## CALIFORNIA COASTAL COMMISSION

STAFF REPORT: APPEALDE NOVO HEARING

APPEAL NO.: **A-1-MEN-01-043**

PROJECT DESCRIPTION: **Construction of a 2,550-square-foot, 18-foot-high, single-family residence with a 625-square-foot detached garage, onsite sewage disposal system, extension of utilities, and installation of 2,500-square-feet of paving for a driveway.**

Figure 1: Relocation of Structures Outside of 25' Sea Cave Setback Retained Septic Leachfield Option

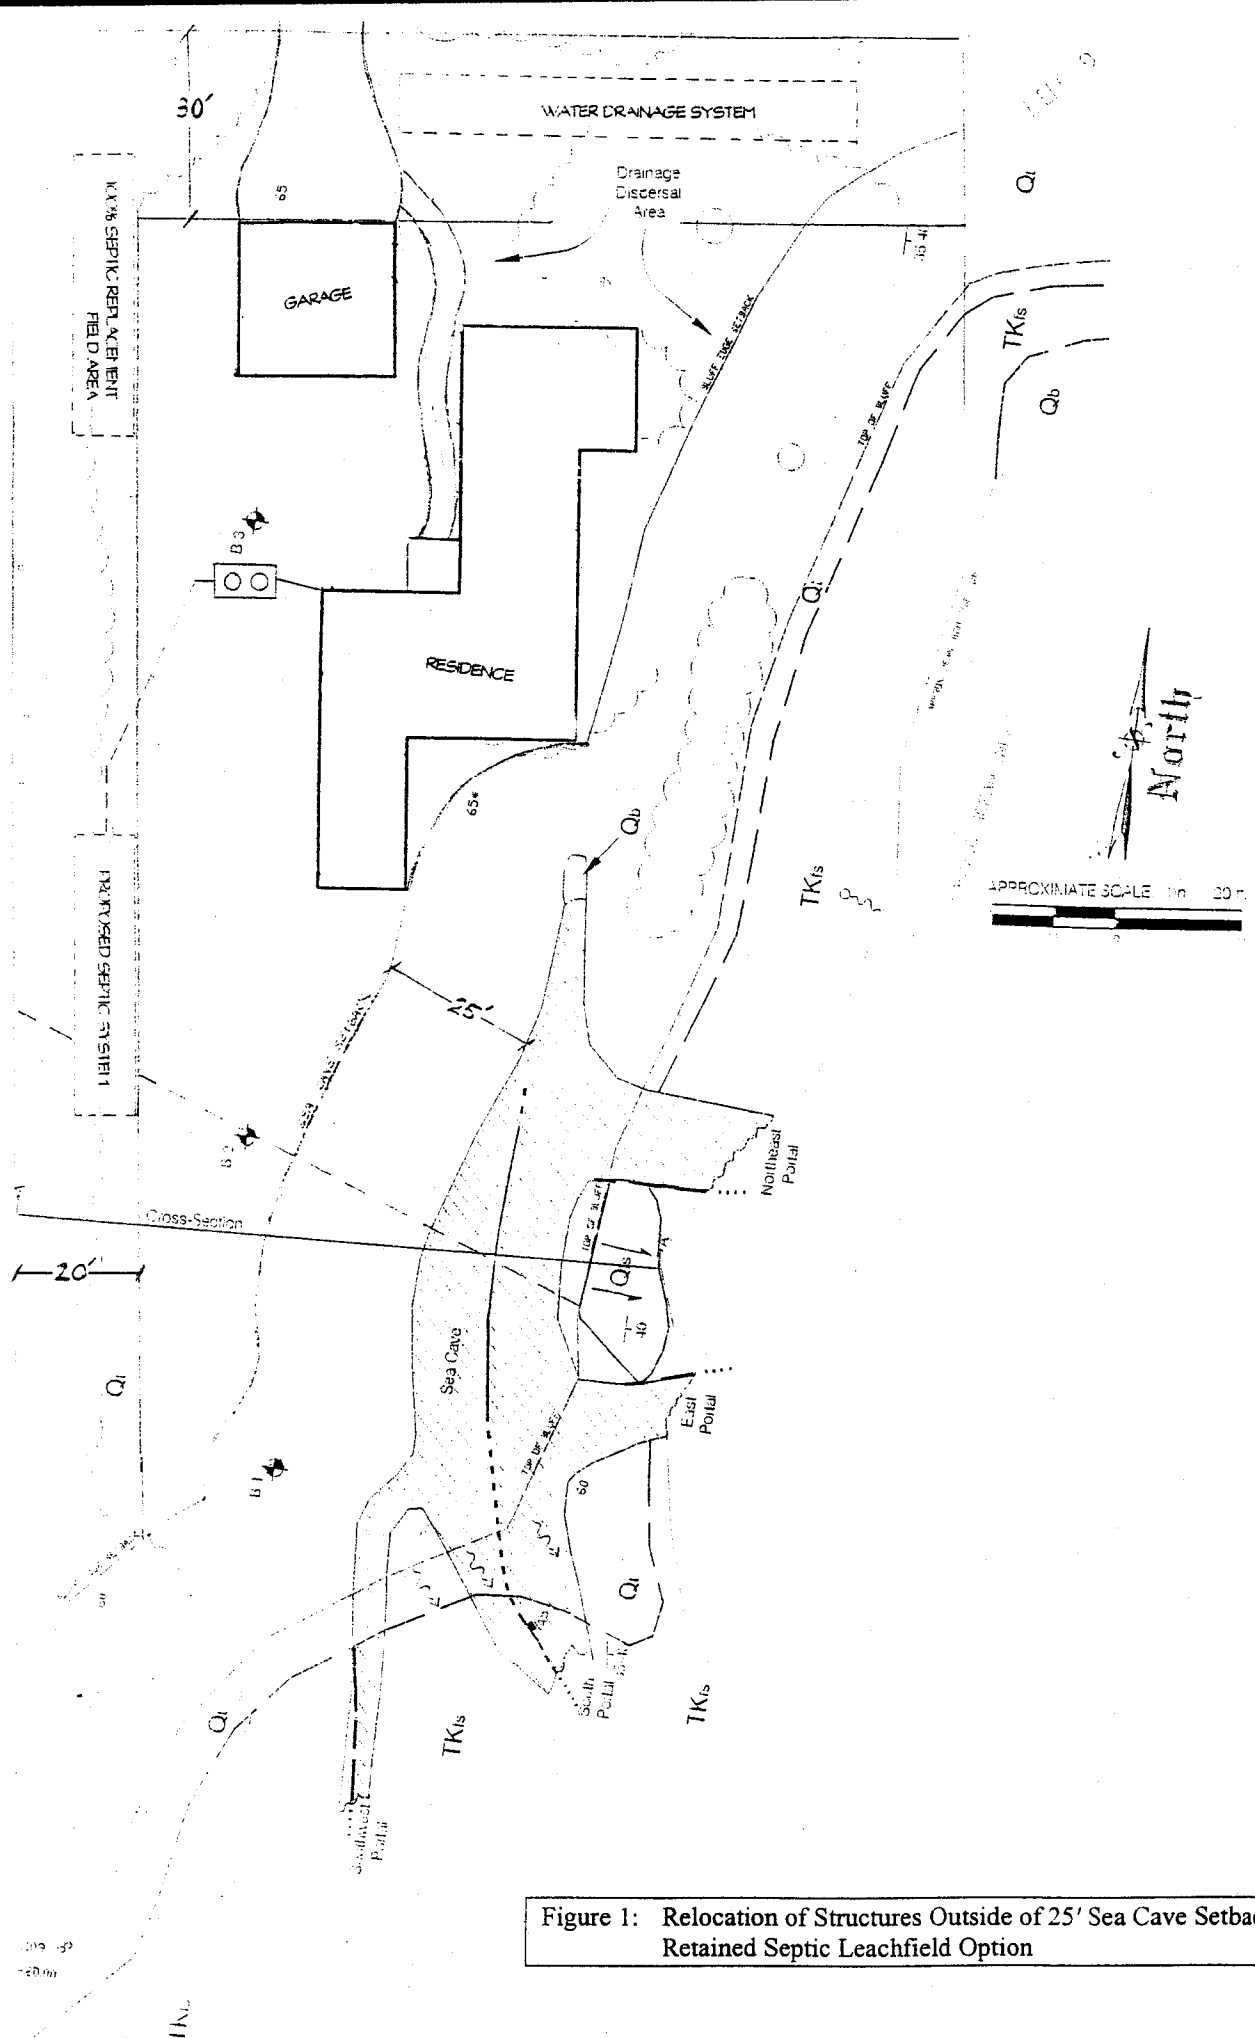
For example, as illustrated in Figure 1 below, it would be feasible to move the house and garage to meet the setback requirements in a manner that would not require moving the proposed and tentatively approved primary and reserve septic system areas should the applicants choose to do so. (Note: For additional information regarding sewage disposal location requirements, refer to Findings Section IV.C.2, above.) In such a case, the house could be relocated approximately 108 feet northeasterly to the north-central portion of the lot. The garage would also need to be relocated approximately 85 feet to the northwest to clear area for the relocated residence and provide a minimum ten-foot separation between the structures, consistent with uniform building and fire codes adopted by the County. Similar reconfiguring would also be necessary for the proposed driveway. This reconfiguration would also have the added benefit of reducing the amount of impervious surface by shortening the required length of the driveway needed for accessing the garage.

Such a relocation would necessitate both removing two trees to the east of the house and possibly shifting the garage more to the west of the house than originally proposed. Removing the trees would not have a significant adverse effect on views from public vantage points because as discussed in Visual Resources Findings Section IV.G.2, below, this portion of the lot where the trees exist is screened from view of the principal public vantage points. Although such a site plan may require clustering of the buildings greater than originally envisioned, area on the lot exists to relocate the proposed structures to accommodate a 25-foot setback, develop required sewage disposal systems consistent with County standards, and provide stormwater treatment facilities for roof and driveway runoff, while abiding by zoning district and subdivision setback standards.

Therefore, the Commission finds that repositioning the buildings to more landward locations to provide a minimum 25-foot setback from both bluff edge and sea cave underlain areas is necessary for the project to conform to the requirements of Coastal Zoning Code Section 20.500.010 that development "*minimize risk to life and property in areas of high geologic, flood and fire hazard*" and "*assure structural integrity and stability.*" Therefore, the Commission attaches Special Condition No. 1. Special Condition No. 1 requires submittal of revised site plans showing the proposed residence and garage set back a minimum of 25 feet from blufftop and sea cave walls, thereby increasing the assurance of structural stability and integrity. Special Condition No. 1 also requires the permittee to construct the development consistent with the approved final plans.

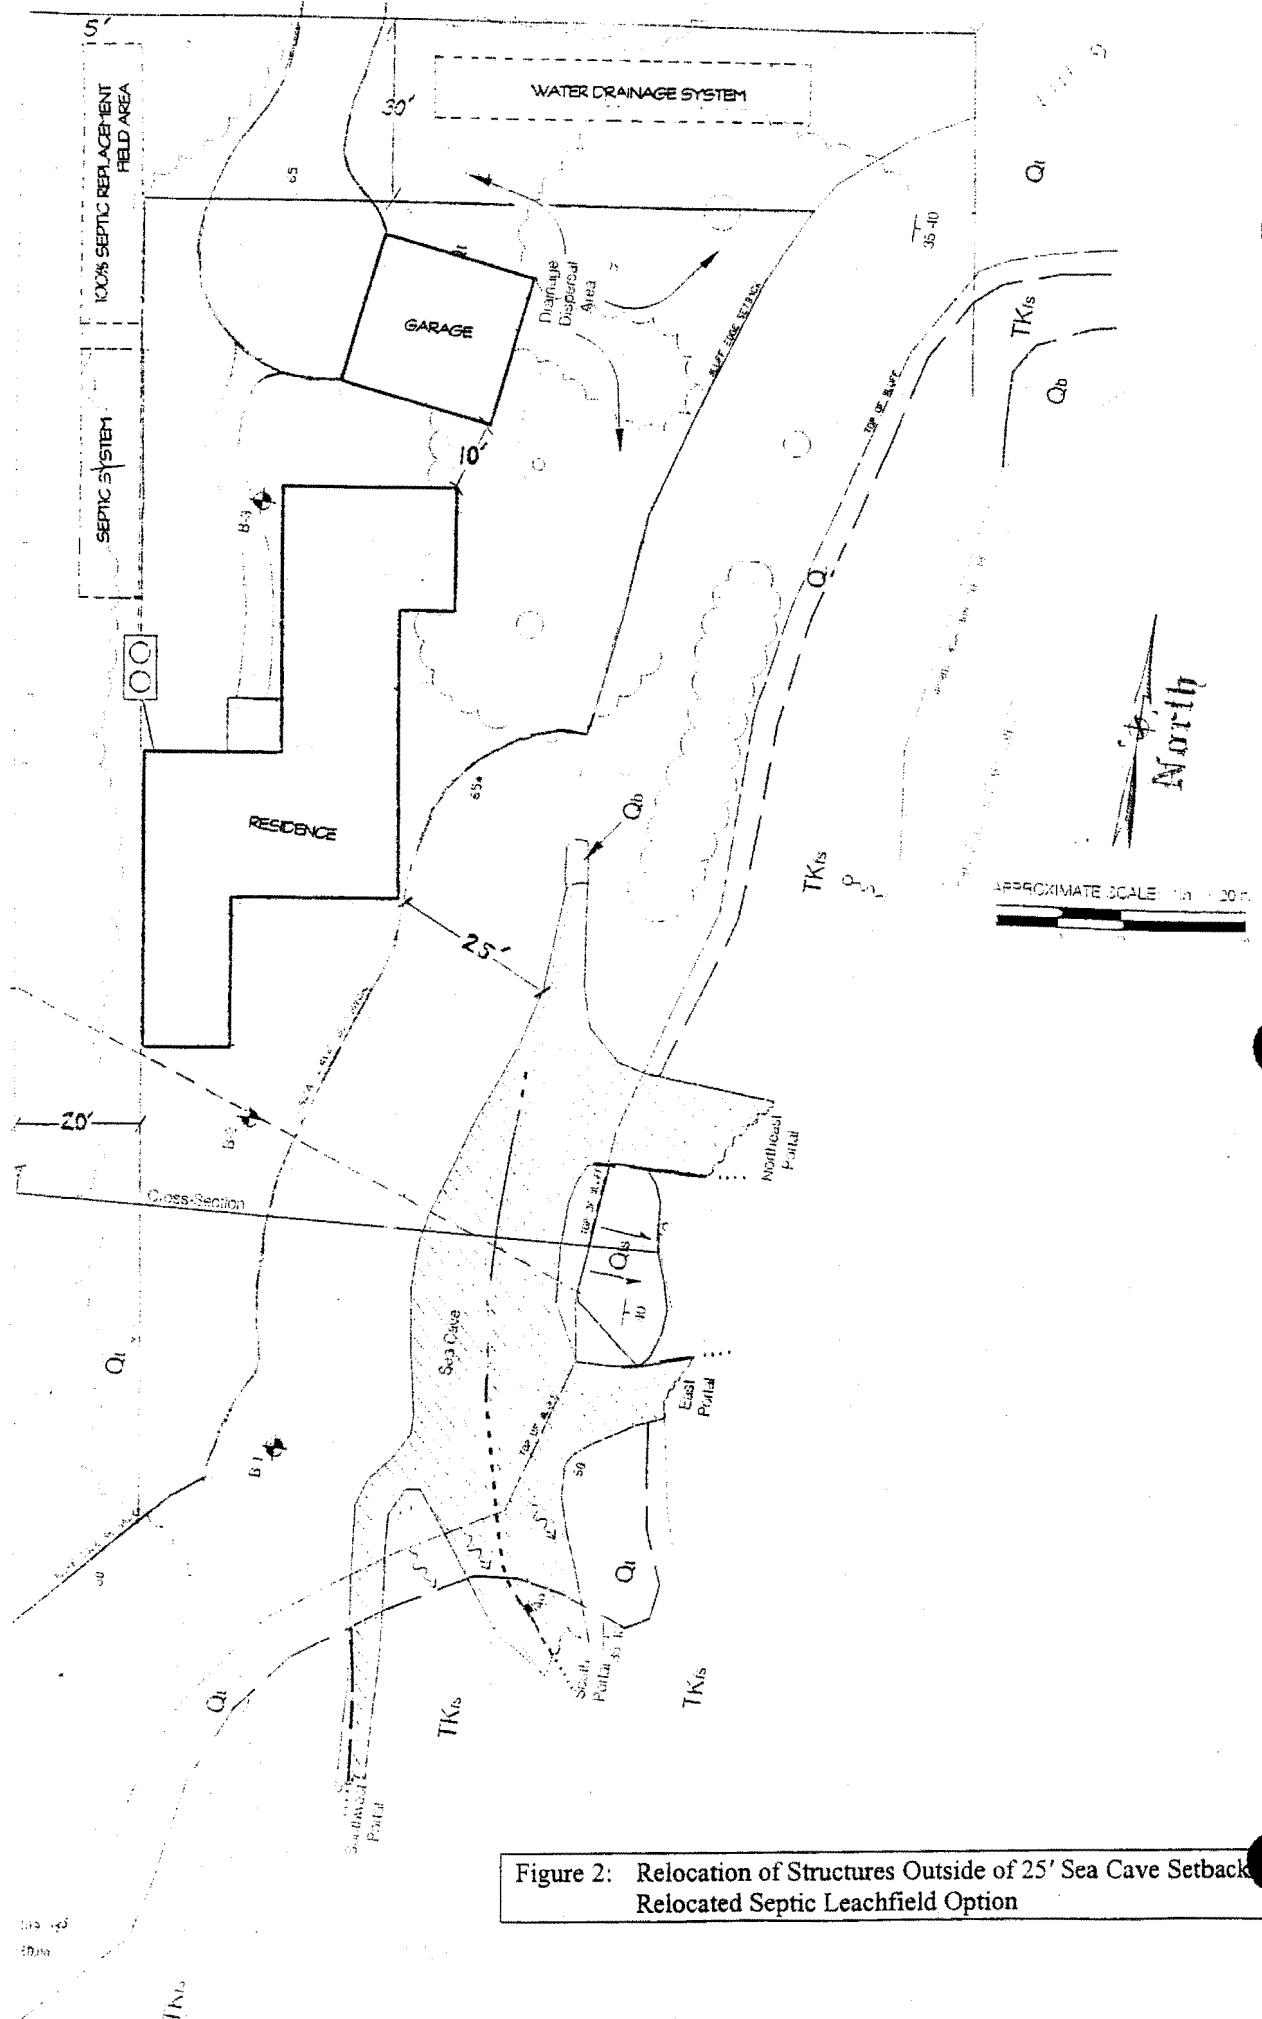
Another siting alternative, illustrated in Figure 2 below, would involve relocating the structures the minimal amount necessary to achieve the recommended 25-foot sea cave setback while maintaining minimum front and side yard standards. For example, the main residence could be relocated approximately 78 feet to the north. The garage would also need to be relocated approximately 65 feet to the northeast to clear area for the relocated residence and provide a minimum ten-foot separation between the structures, consistent with uniform building and fire

codes adopted by the County. This option would not necessitate removing any trees, however, to maintain the same plumbing outlet point and comply with sewage disposal system standards for minimum setbacks from structures, the septic system would need to be relocated.

Figure 2 shows one potential configuration wherein the septic system has been shifted northerly within the western side yard approximately 70 feet. The soil suitability information developed for the site indicates that septic capacity of the parcel is good (i.e., Zones "2A" and "2B") and this location is generally in the same location where the DEH approved the siting of the replacement leach field system under the applicants' proposed site plan. In addition, both the certified professional soil scientist who prepared the sewage disposal system proposal and the DEH staff member who approved the proposed design have indicated that the site has some flexibility to accommodate relocating the septic system to other portions of the parcel subject to field verification of compliance with requisite setbacks. As discussed in Findings Section IV. C.2 above, Special Condition No. 6 requires that if the septic system is relocated, the applicants are required to submit evidence that DEH approves of the new location to ensure that the project would be developed in a manner consistent with the septic system requirements incorporated into the LCP.

Attachment: Modified Plate 12

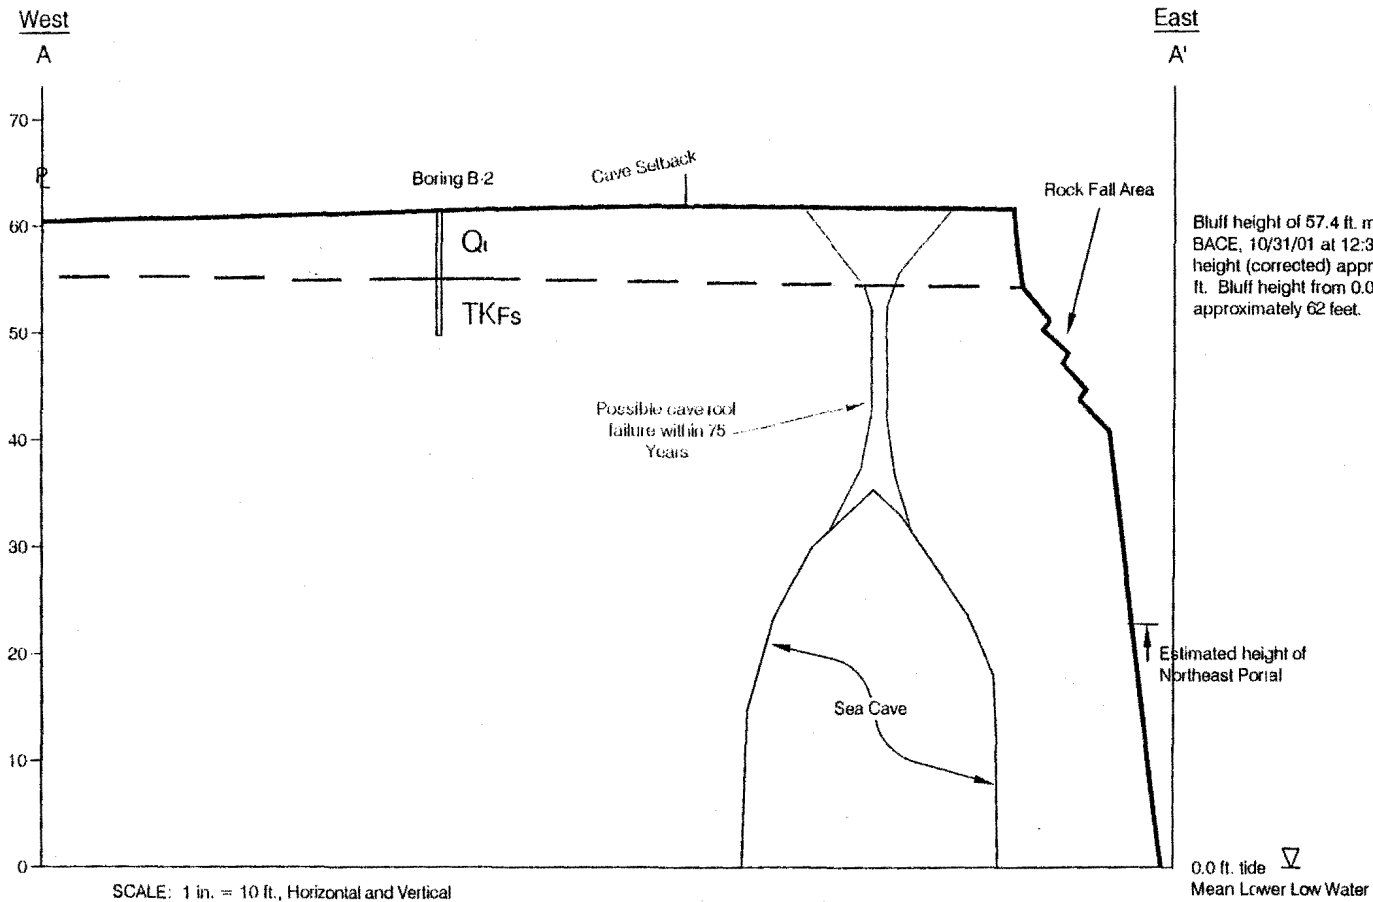
The 22 February 2002 BACE letter suggests that a partial roof collapse leading to a skylight entrance to the cave is the most likely failure mechanism, and provides a schematic of what such a collapse might look like, using a modified version of cross section A-A' from their earlier report. The letter further states that a collapse of the entire roof of the cave, along a failure plane closer, or coincident with, the rear wall of the cave "could take an additional several hundred years." Although the failure mechanism envisioned in the BACE letter is quite possible, I believe a "total collapse," in addition to other types of "partial collapse," are equally possible. Experience in other parts of the state has demonstrated that sea caves can and do collapse suddenly in their entirety (several recent collapses in Solana Beach have been of this variety), or more gradually, in parts, leading to arches, sea stacks, and similar offshore features such as are common on the Mendocino coast. Maps of sea caves on Santa Cruz Island, prepared by the Southern California Sea Cave Survey (see Bunnell, 1988), show a wide variety of collapse features. In the present case, there simply are not sufficient data available to constrain the most likely collapse mechanism.

- Given the likelihood that the friable soil mantle overlying the collapsed area would erode back to a shallow angle of repose, a 25-foot setback would provide greater protection for the structure than would a five-foot setback. In addition, if the cave were to unexpectedly increase in size due to erosion to a degree that could endanger structures in the future, a greater setback would afford ample time to recognize the danger and take remedial action (i.e. relocate the structure, re-engineer the foundation) short of having to immediately install a shoreline protective structure such as a sea wall.
